# Technical Service Bulletin

## 90 Traffic sign dependent speed limit setting default to "On" after ignition cycle

90 23 65 2072530/1 December 21, 2023.

Model(s)	Year	VIN Range	Vehicle-Specific Equipment
e-tron GT, and RS e-tron GT	2024	All	Not Applicable

Figure 1: Traffic sign-based speed warning setting.

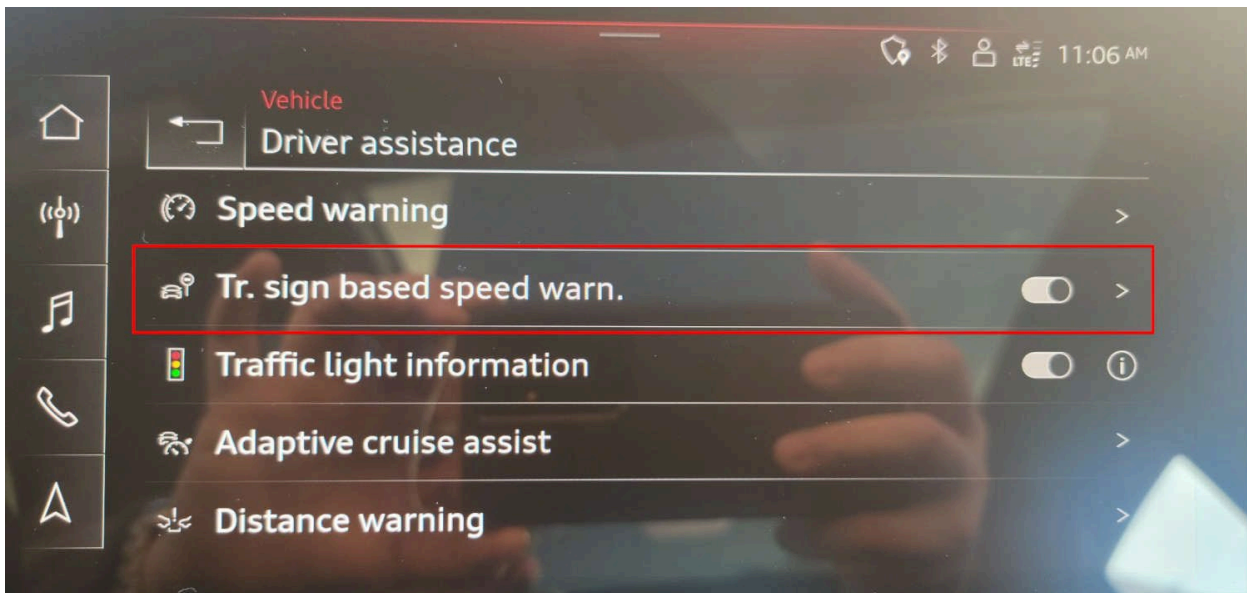
- The Traffic sign dependent speed warning setting automatically reactivates every time the ignition is turned on (Figure 1).

Due to a new requirement in Europe, the traffic sign dependent speed limit setting is activated every time the ignition is turned on, regardless of its last setting. This is however not the intended functionality for other markets outside of Europe. A new ZDC is provided for those markets to revert to the previous, "last mode" functionality.

New Target Data Container (ZDC) update in the driver assistant systems control module, J1121 (address word 00A5) addressed the condition.

1. Follow all instructions in TSB 2011732: 00 Software Version Management (SVM), operating instructions.
2. Update the Target Data Container in the driver assistant systems control module -J1121- (address word 00A5) using the SVM action code as listed in the table below, if necessary:
